RBKC MOE - P1
Comments in blue by RBKC Building Control

**GRENFELL TOWER
REGENERATION PROJECT**
Phase 1

FIRE ACCESS PLAN

1275 (05) 100 00 BS

1 MEZZANINE
1:100

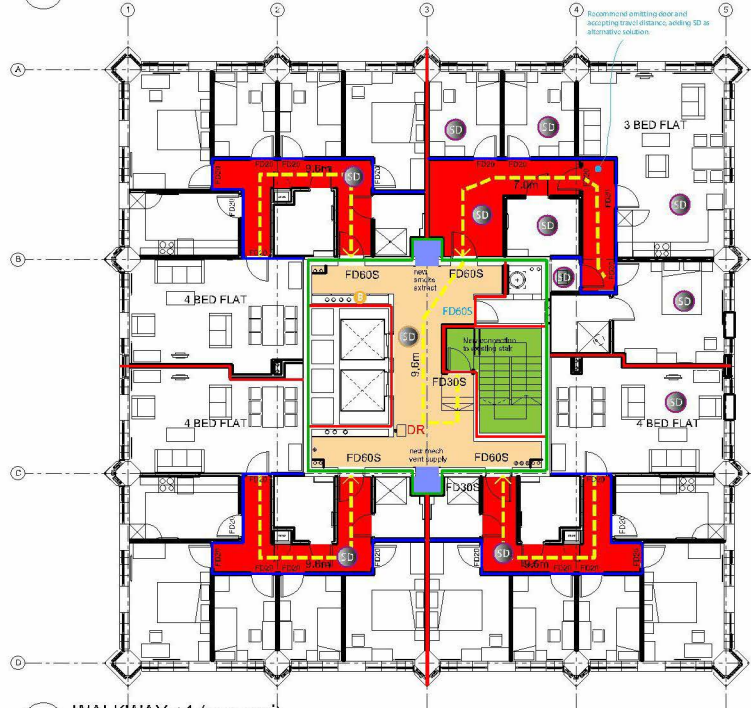
No details of existing extract / supply rates are given therefore no consideration could be given of adverse effect on existing systems. If system designers wish to redesign the system without consideration of adverse effect, justification for the proposed extract rate needs to be submitted, including performance modelling.

A Office Stair
1:100

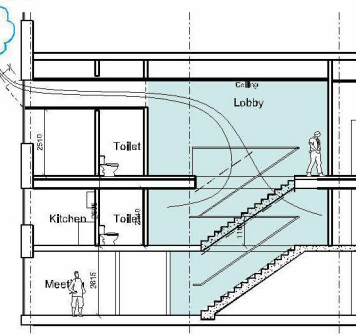
This is a room. Venting the room would not provide the same level of protection as venting a lobby thereto. In this case an unvented lobby separation to the residential escape is considered appropriate.

2 WALKWAY LEVEL
1:100

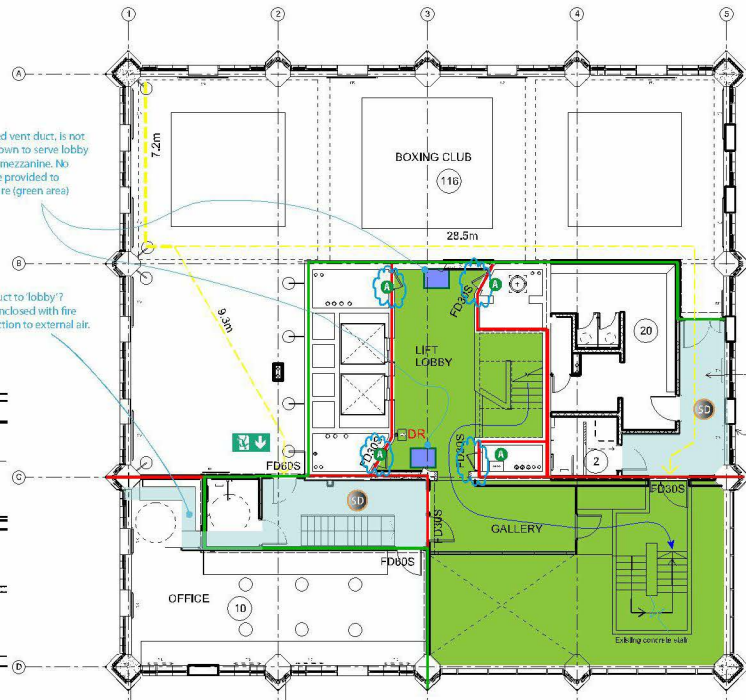
Risers accessed from Stairway
Access should not be provided to services from the single stairway. (Hot and cold water/dry riser services are acceptable in metal pipes with suitable fire stopping). (Note in the existing building these risers were in the lobby). Can these access panels be sealed at this level?

Risers accessed from common Lobbies
Fire resistance should be achieved from the riser side of the enclosure. Access to services from the lobby should be via an FD30S with Fire Door Keep Locked Shut Signage.
